Thank you for taking the time to speak with me last week regarding DA A006774817 for 11–15 Swinburne Street and the impacts on my property

Re: Submission – Impact Assessable Development Application
Council Reference: A006774817
Site: 11 & 15 Swinburne Street, Lutwyche QLD 4030
Date: 28 January 2026

Re: Supplementary Submissions – Amended Plans (1 May 2026); Amended Landscape Plan (7 May 2026)
Council Reference: A006774817
Site: 11 & 15 Swinburne Street, Lutwyche QLD 4030
Date: 14 May 2026

CONCEPT BULK EARTHWORKS SECTION SHEET 1

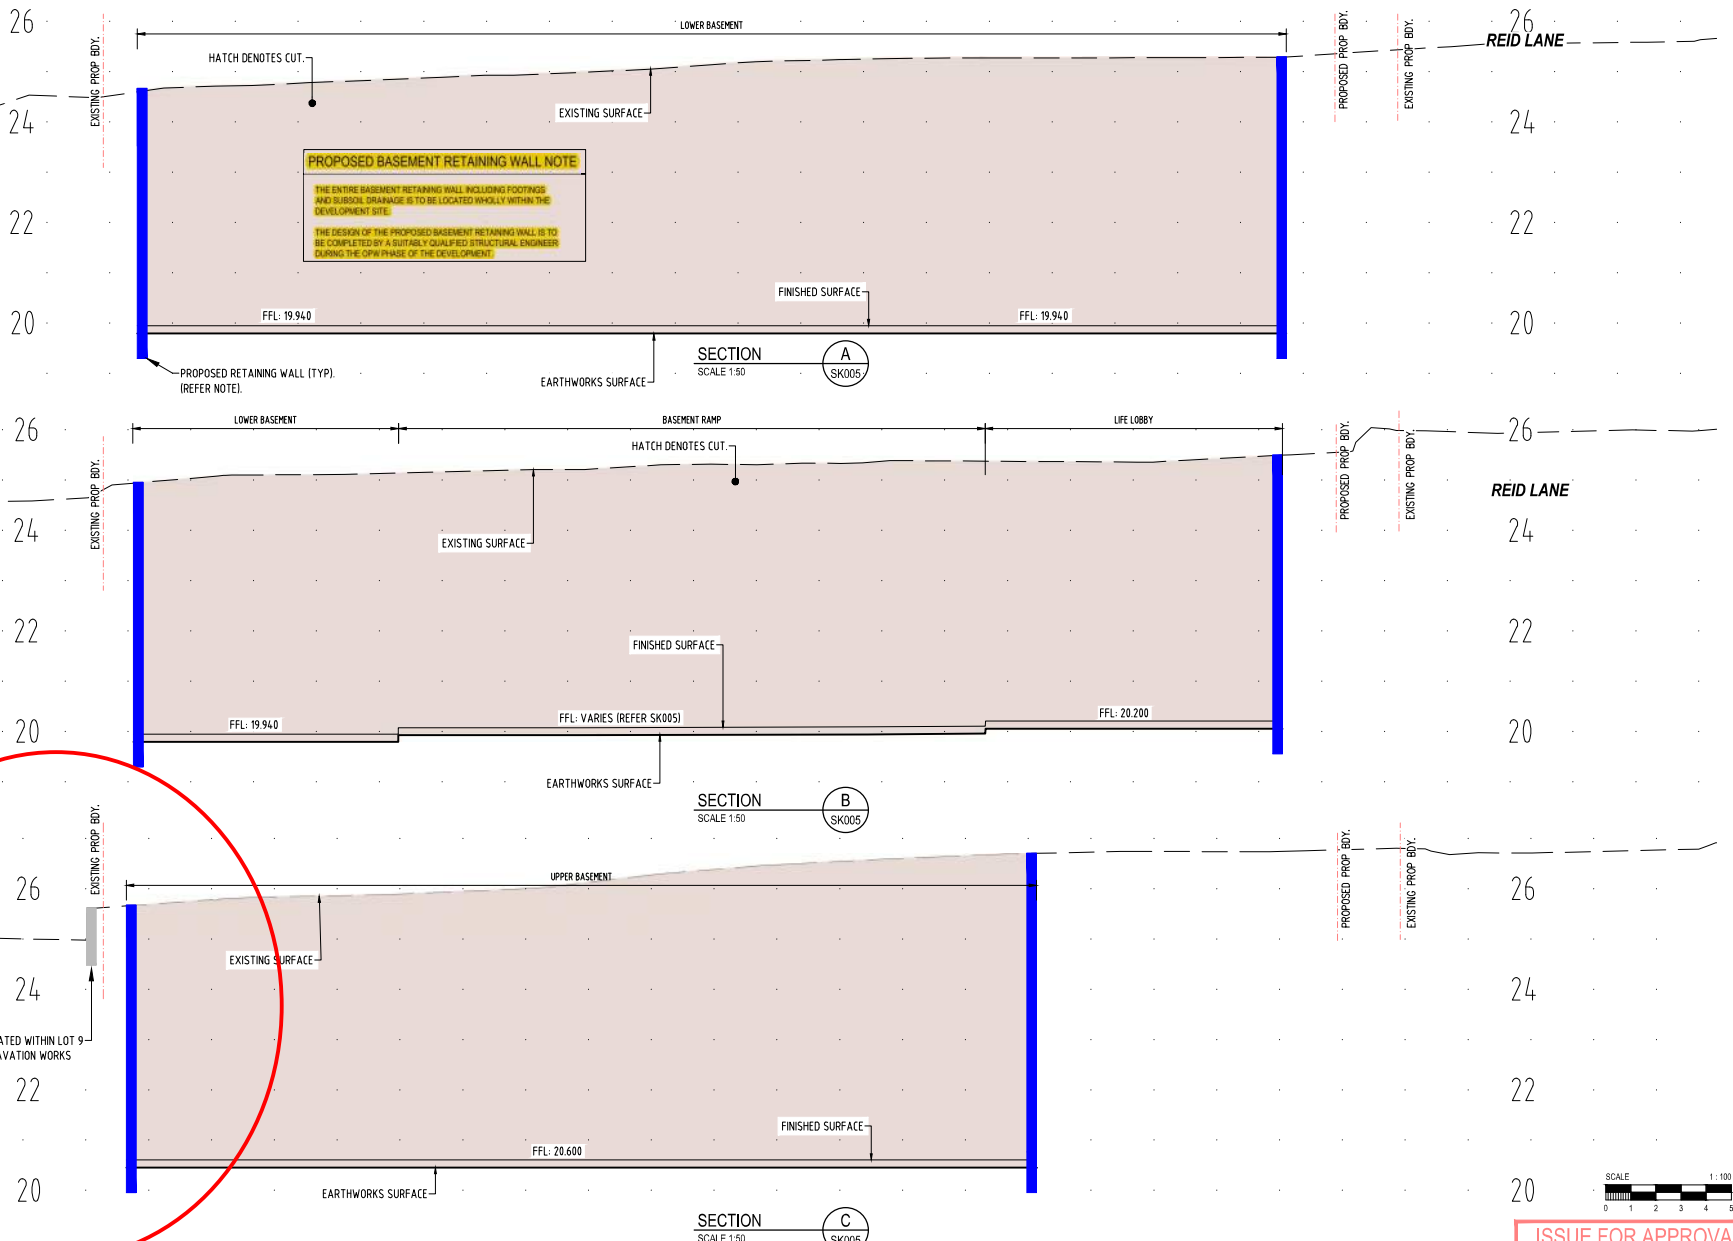
The proposal relies on a deep basement excavation located extremely close to the western property boundary, with the basement wall shown at approximately **400 mm offset** from the boundary (**Attachment 2**).

The submitted sections indicate a retained excavation depth of approximately **6.4 m** at the western boundary interface (Ground Level RL 26.365 to Basement 2 RL 19.940).

At this depth and proximity to a boundary, the retaining system cannot reasonably be assumed to be a simple or “standard” wall. A realistic solution would typically involve **bored piles / bored piers**, including capping beams, construction tolerances, waterproofing and drainage zones. However, the publicly notified drawings show a basement wall of **negligible thickness** and do not include the level of detail normally expected for a deep boundary excavation.

This concern is reinforced by the civil engineering documentation, which includes disclaimers that the drawings are **indicative only** and expressly defers detailed retaining wall design to the **Operational Works (OPW)** stage (**Attachment 3**). Given the depth of excavation and minimal boundary offset, deferring this matter to OPW is inappropriate. The basement retention solution is fundamental to the building form and interface outcome and must be resolved at development application stage.

Neighbouring approval – 23 & 25 Swinburne Street, Lutwyche
(*Council File Reference: A004827631*) – basement plan extract
showing bored pile / bored pier retaining wall system and ~3.0 m
basement offset to side boundary

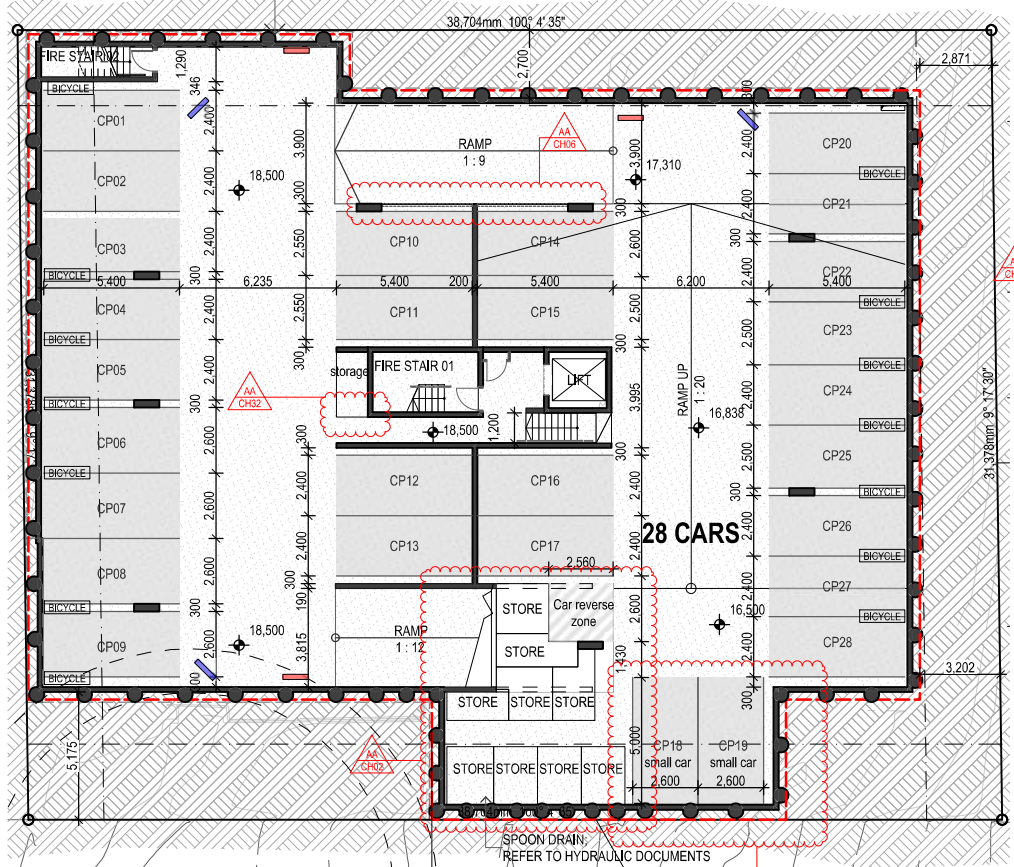
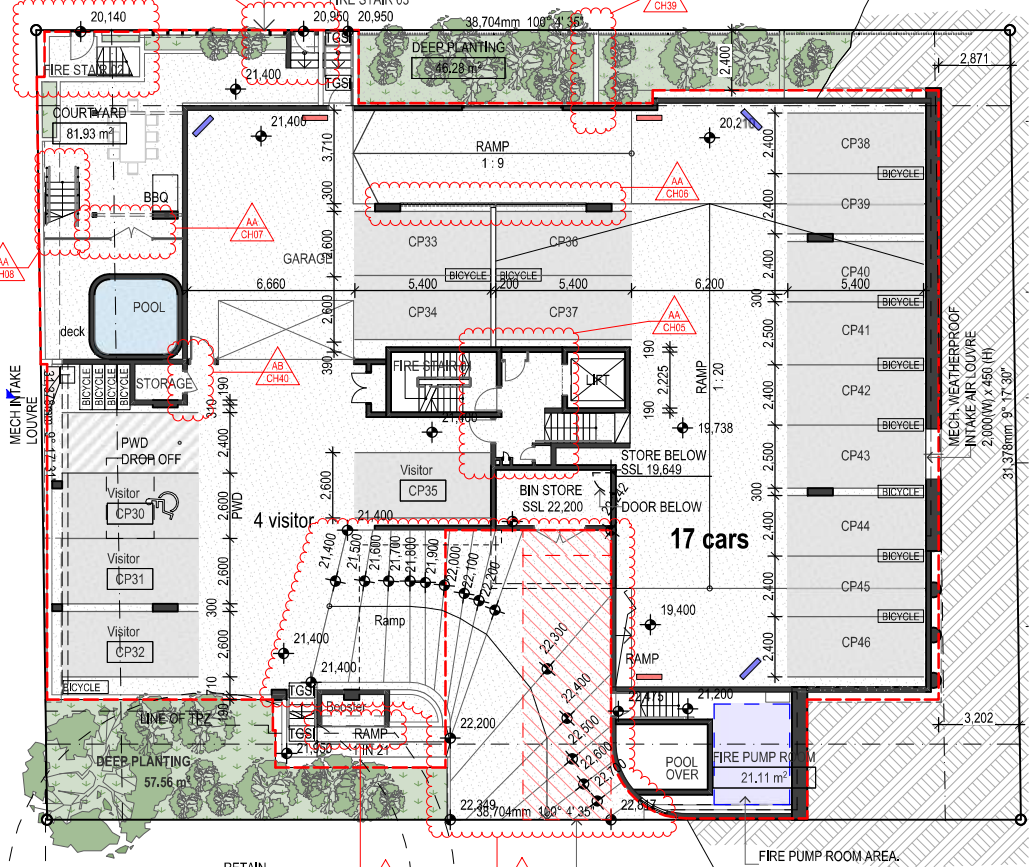
- a **~3.0 m separation** between the basement wall and the only sensitive residential interface;
- a **bored pile / bored pier retaining wall system** with realistic wall thickness and construction allowances (**Attachment 4**); and
- **meaningful deep-soil planting** along the residential boundary (**Attachment 5**).

Importantly, that outcome was achieved through a deliberate layout response, with the basement and built form oriented toward **non-sensitive boundaries** (open space and Reid Lane), thereby protecting the sole residential interface.

Neighbouring approval – 23 & 25 Swinburne Street, Lutwyche
(Council File Reference: A004827631) – extract showing strong
side boundary deep planting buffer/interface outcome

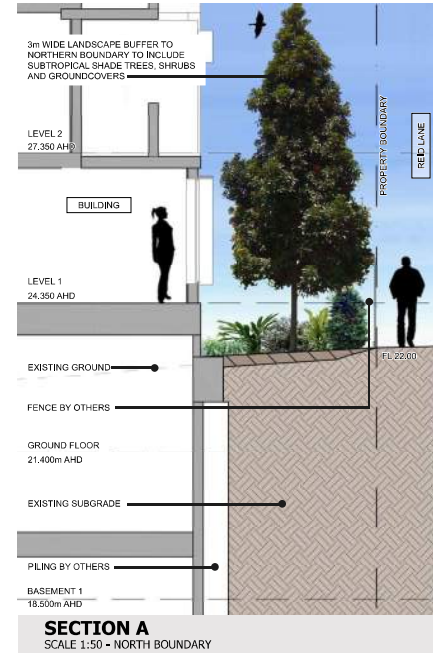
Accordingly, I respectfully request that Council require the proposal to be amended to deliver a **western boundary interface outcome consistent with approval A004827631**, including a **genuine deep-soil landscape setback of approximately 3.0 m** along the western boundary (not containerised or planter-box landscaping). This approach would:
